SANTA ROSA COUNTY
ENGINEERING DEPARTMENT
6051 Old Bagdad Highway, Suite 300 | Milton, Florida 32583

MEMORANDUM

RE: Heather's Place S/D

Discussion of David Fitzpatrick, P.E.'s request for a waiver to construct a boulevard entrance into Heather's Place.

HEATHER'S PLACE

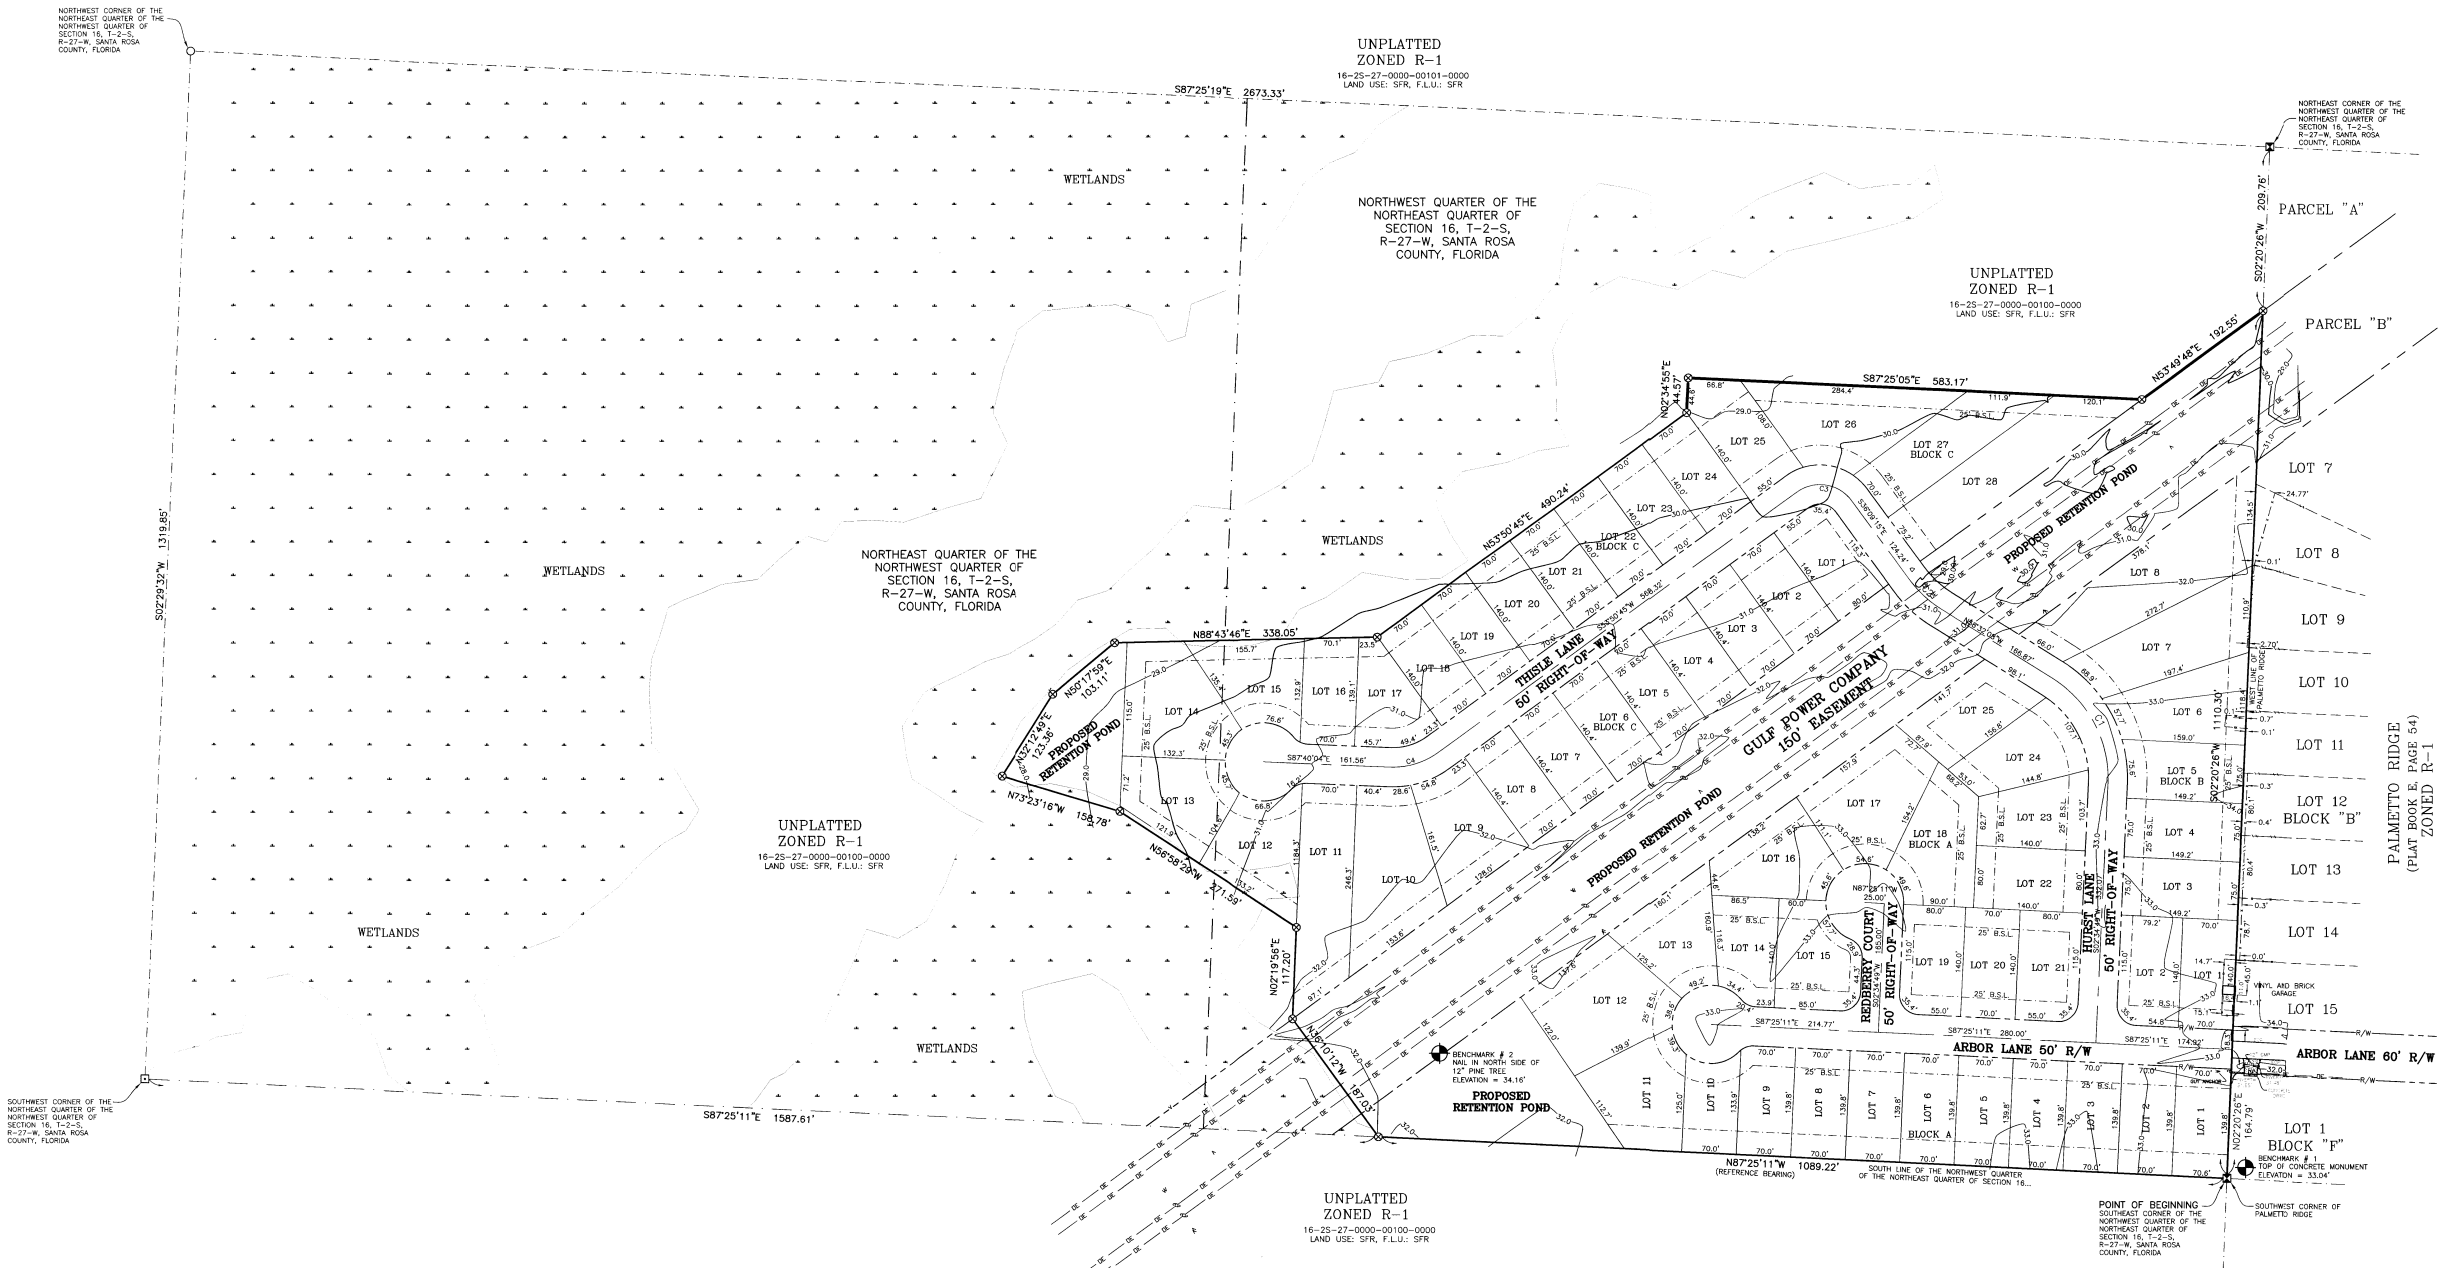
LDC 4.03.03.B.3.b requires a subdivision of 50 lots or more have 2 entrances or a boulevard entrance to the first looped street. Entrance to the subdivision will be from a 110 foot stub-out of Arbor Lane that is constructed as a non-boulevard street. It is not recommended that this portion of Arbor Lane be removed and reconstructed as a boulevard. Also, a boulevard requires a 65 foot right-of-way and Arbor Lane has only a 60 foot right-of-way. Subsequent phases of this development will provide for a second entrance.

We respectfully request a variance to the boulevard entrance requirement of the land development code. The referenced proposed subdivision is comprised of 60 single family homes.

- The subdivision access point is Arbor Lane an existing 60' county right of way stubout to the subject development. Santa Rosa County Engineering staff has requested that the existing right of way not be converted into a boulevard type entrance and that we simply connect to the existing asphalt stubout there.
- The applicant is planning a 2nd phase to this development in the future which will connect to another county right of way. This connection would negate the need for a boulevard entrance at Arbor Lane.

Board approve or deny a variance for the boulevard entrance into Heather's Place.
